CITY OF ALBUQUERQUE

**Re: Murphy Express, Wyoming
1358 Wyoming Blvd NE
30-Day Temporary Certificate of Occupancy
Transportation Development Final Inspection
Engineer's/Architect's Stamp dated 11-3-17 (J20D037)
Certification dated 7-2-19**

SHEET NO.
TCL-1

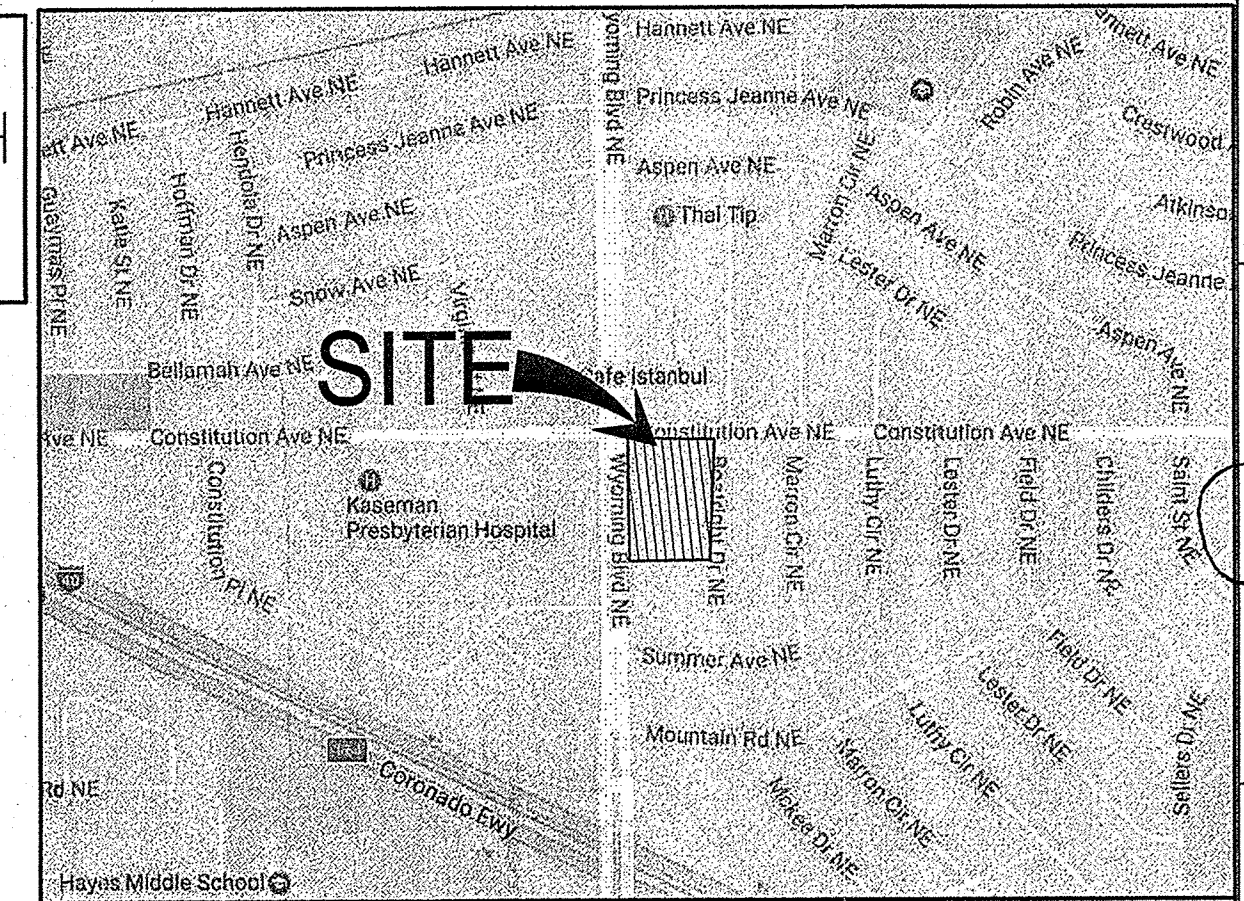
1. Please complete Alley Paving.
2. Please add Truncated Domes to access of Wyoming.
